University of South Carolina
Controllers Suite Renovations
1600 Hampton Street-6th Floor
Columbia, South Carolina

March 7, 2014

ADDENDUM No. 1

ROOM FINISH SCHEDULE table with columns: NAME, FLOOR (MATERIAL), BASE (MATERIAL), CEILING (MATERIAL), WALL FINISH (NORTH, EAST, SOUTH, WEST), COMMENTS. Rows include room finishes like 602, 603, 603A, etc.

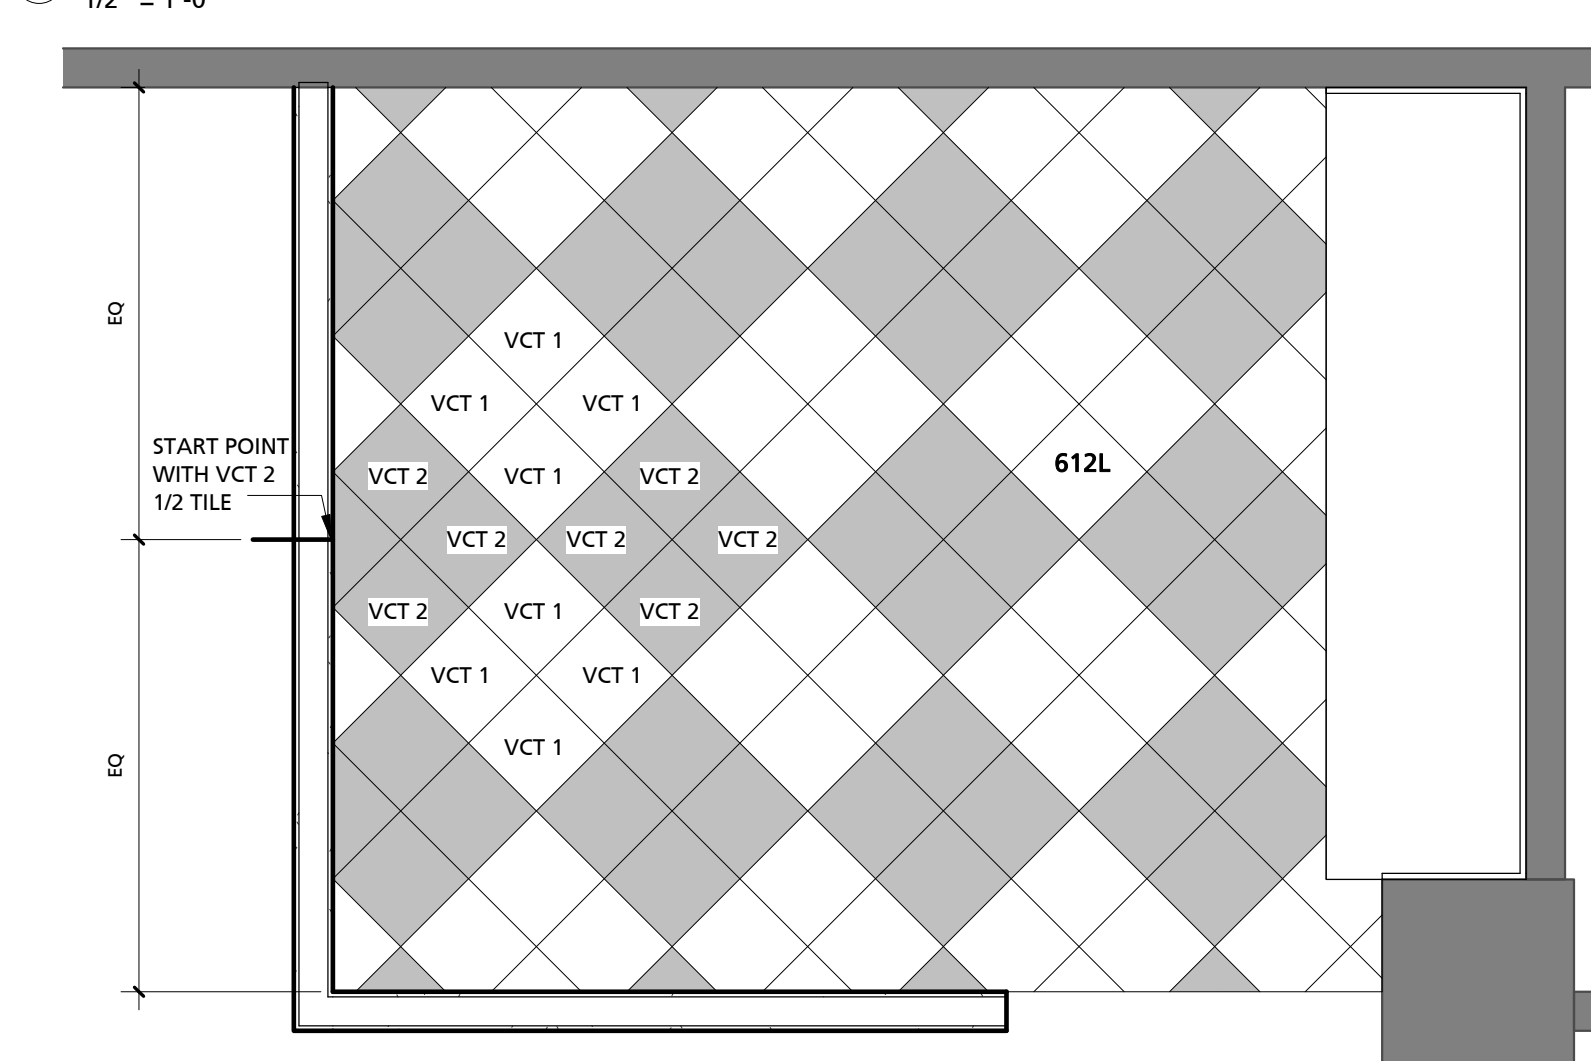
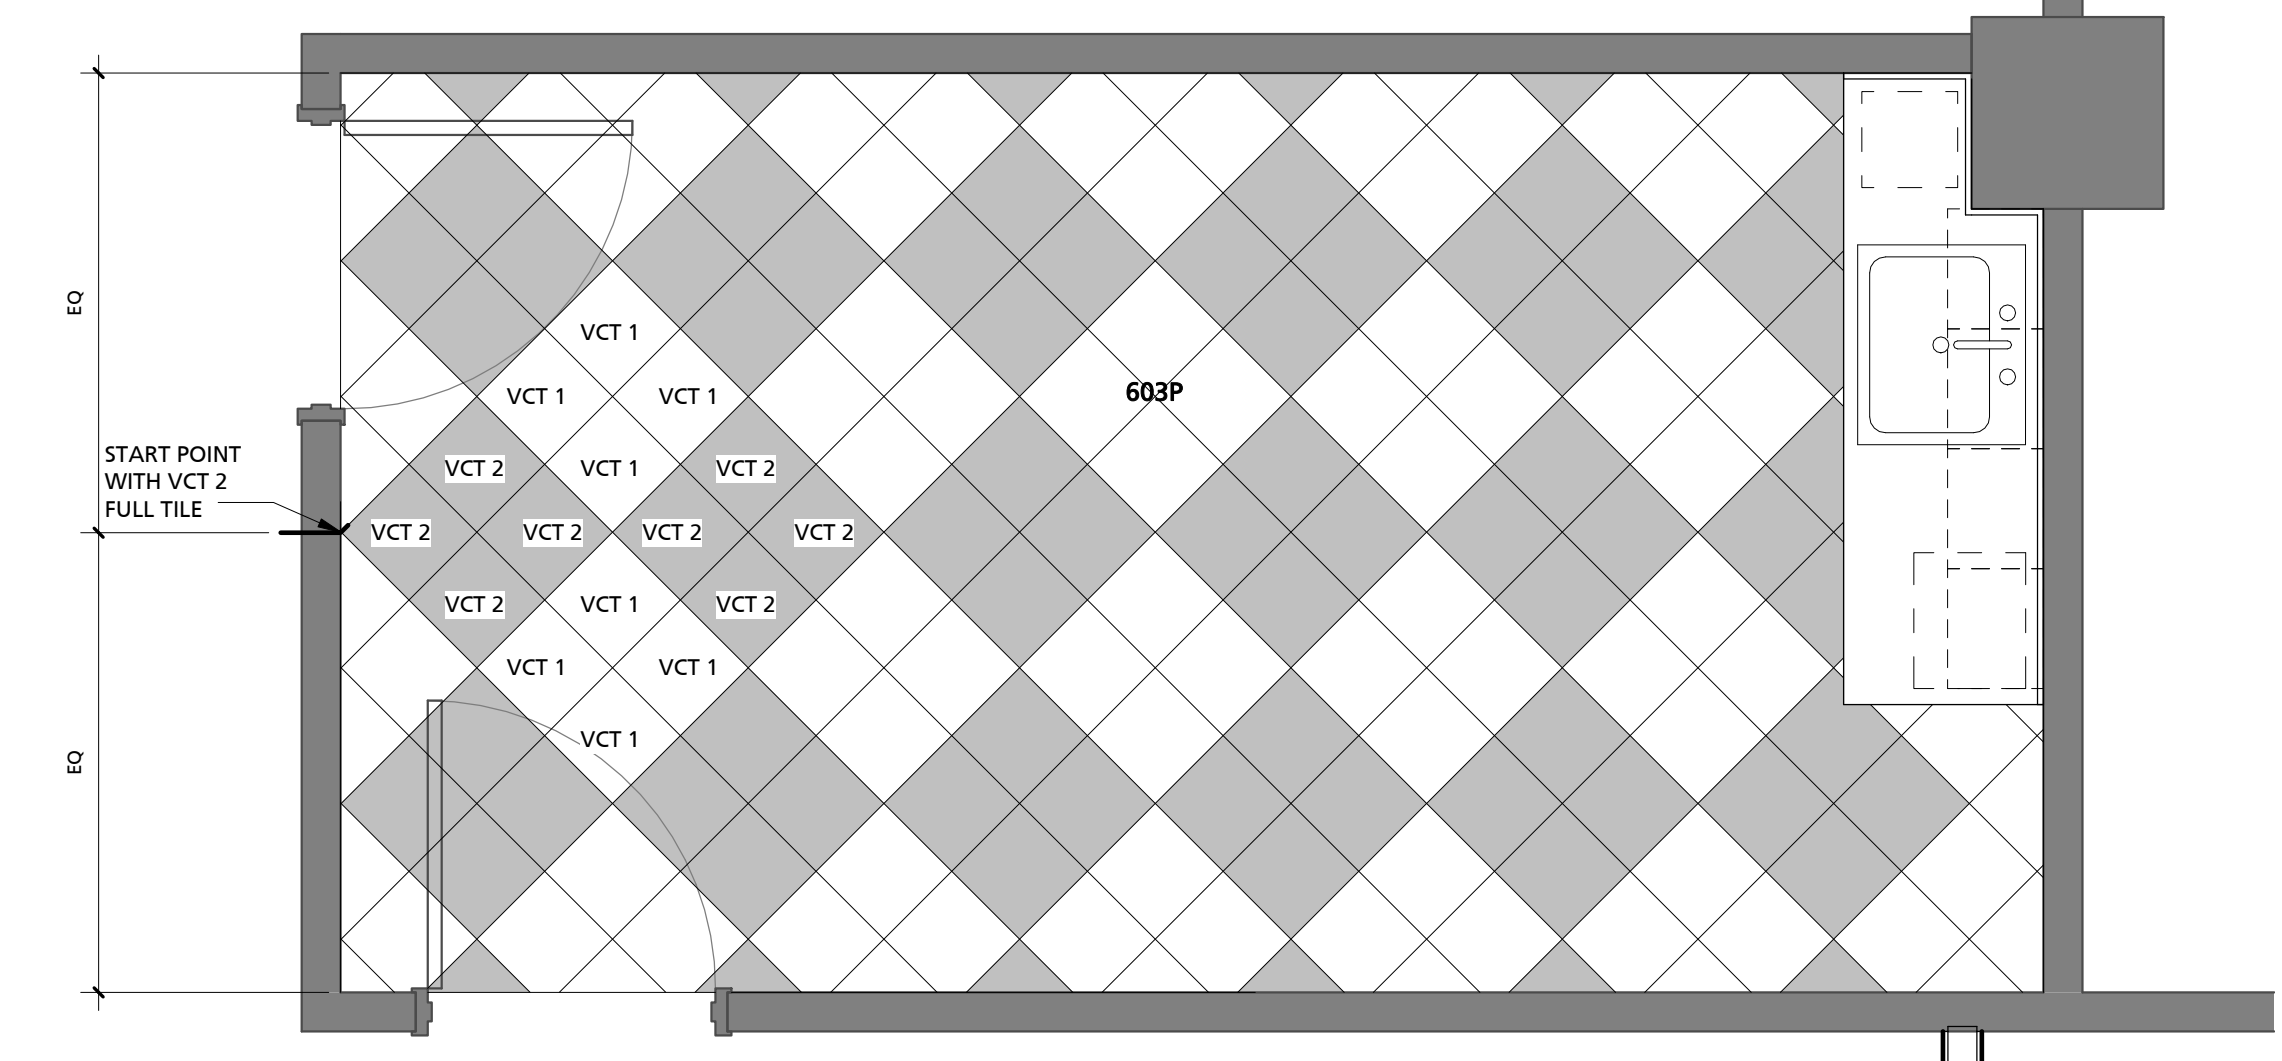
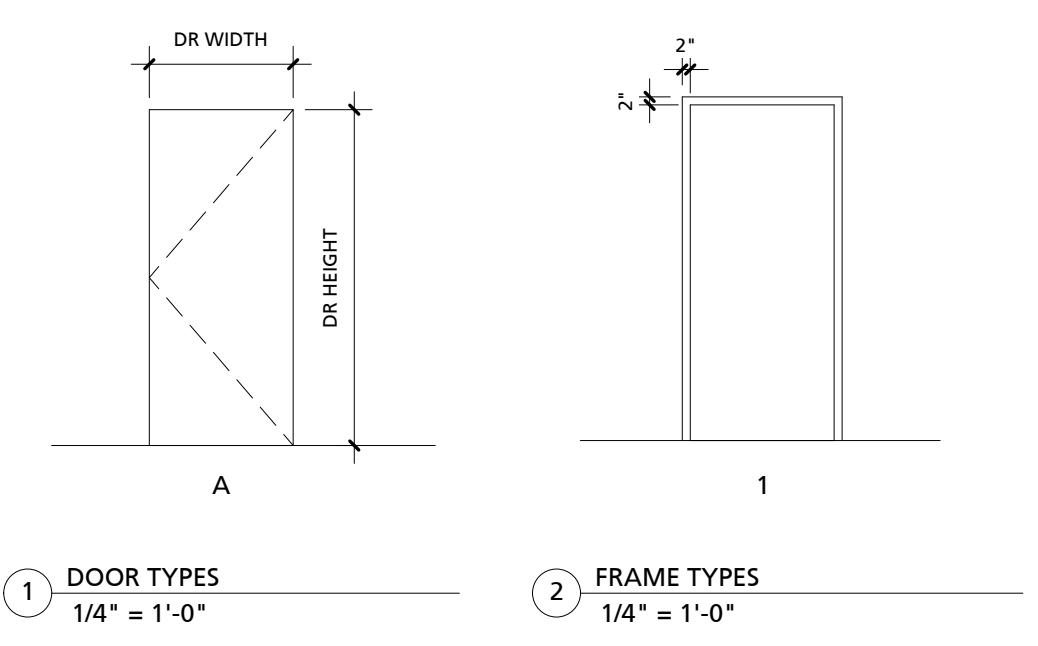
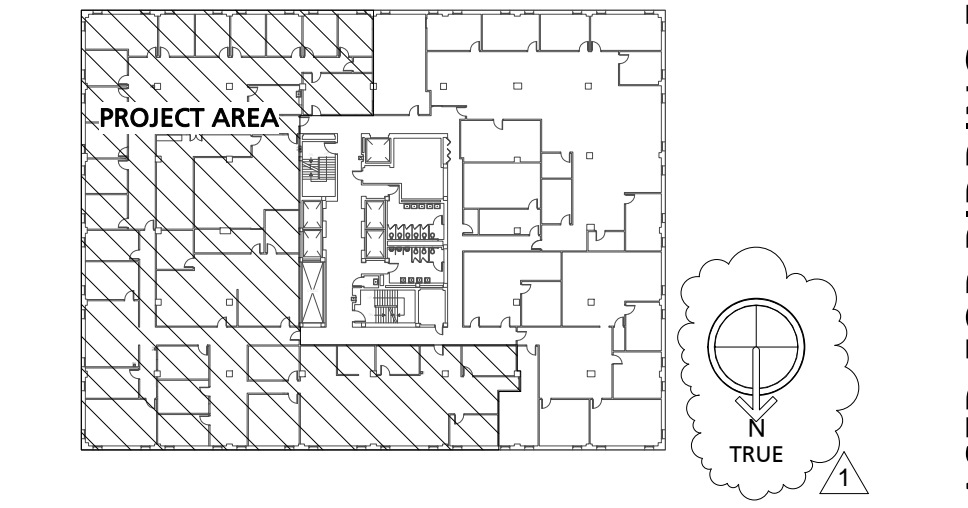
1. QUESTION: There are several spaces on the Room Finish Schedule that have a dashed line in the floor and base finish columns. One example is space 614, an open space that contains several other finish spaces 614d, e f, etc. Should they receive a finish also?

- a. Key Plan: True North Added
 - b. Detail 1: Notes added
5. Reference Sheet A801 – DELETE Sheet A801 dated 02.24.14, ADD in its place Sheet A801 dated 02.24.14, revised 03.07.14, see attached.

- a. Key Plan: True North Added
 - b. General Door Notes: Note F revised to include hinges.
 - c. Door Schedule: Revisions to door comments and hardware

- d. Room Finish Schedule: Furniture Tags and associated areas deleted, revisions to finishes
 - e. Room Finish Specifications: Plastic Laminate selections added; Carpet Tile selection modified

ANSWER: See revised sheet A801, attached.
2. QUESTION: Who do we contact to make arrangements for subcontractors to visit the site?
ANSWER: An additional site visit has been scheduled for Monday, March 10, 2014 at 10:00am. We will meet at 1600 Hampton on the 6th floor in the elevator lobby. The site visit will be from 10-11 am. This will be the only additional site visit.

FURNITURE TAGS, AND ASSOCIATED AREAS, DELETED.

2 CASEWORK ELEVATION-603P
1/2" = 1'-0"

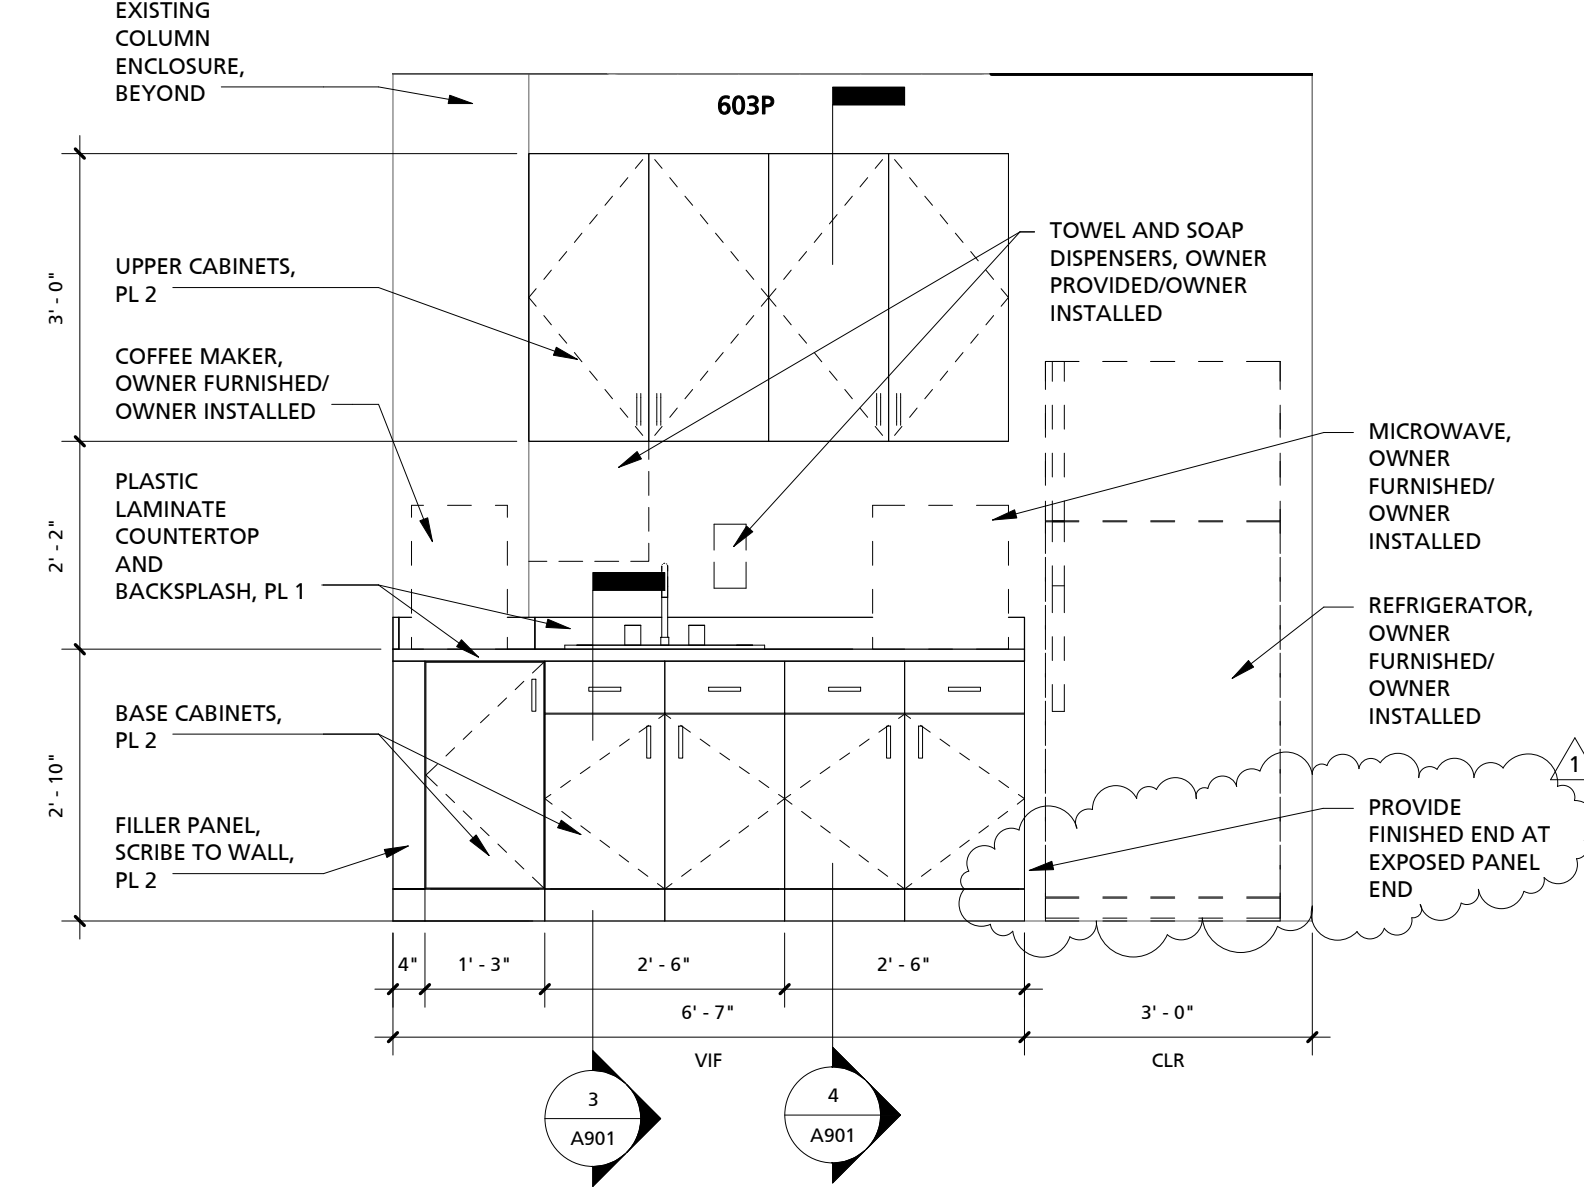
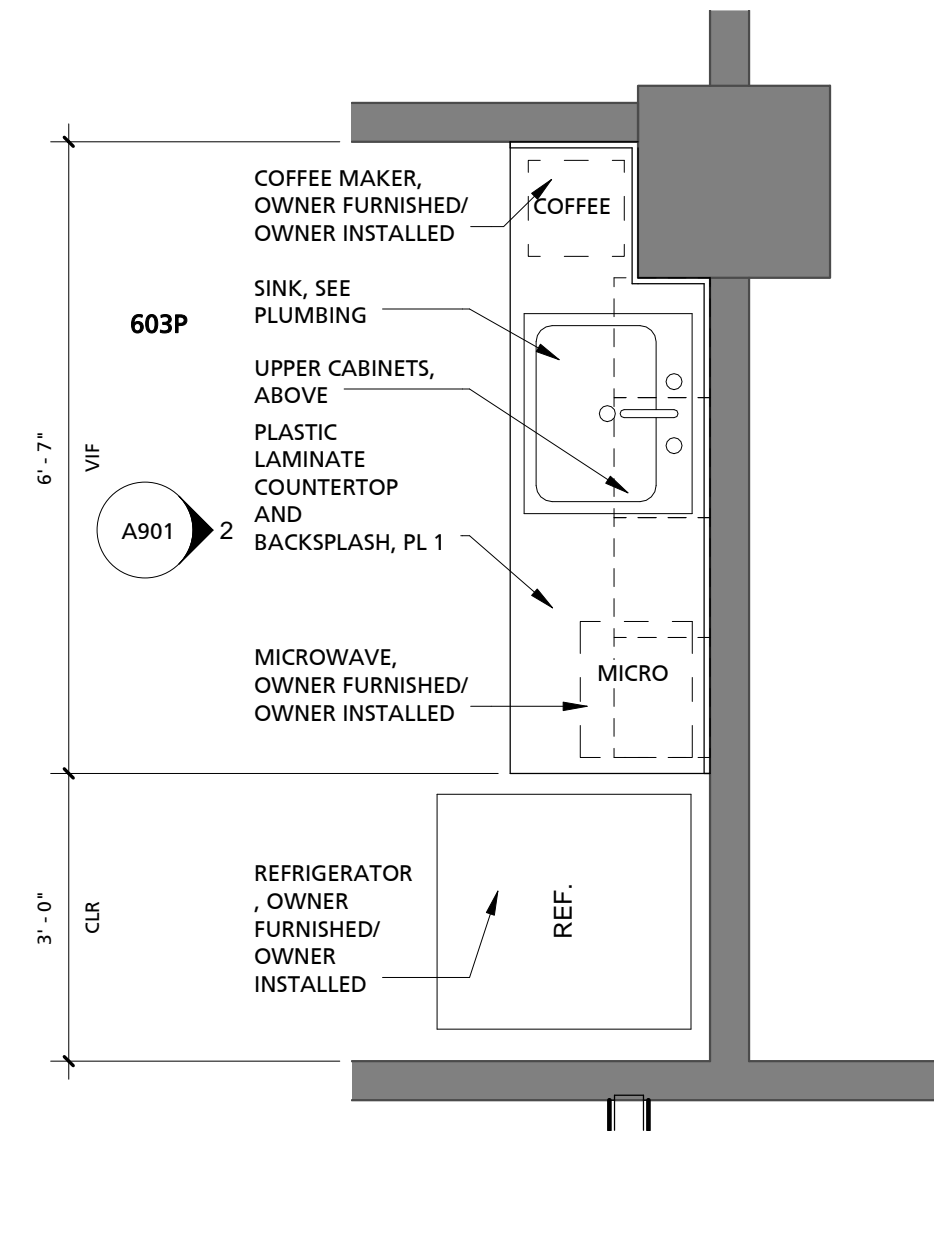
6. Reference Sheet A901 – DELETE Sheet A901 dated 02.24.14, ADD in its place Sheet A901 dated 02.24.14, revised 03.07.14, see attached.
 - a. Detail 2: Note Added
7. Reference Sheet E102, dated 02.24.14: AMEND per sketch SK-E1, dated 02.24.13, revised 03.07.14, attached.
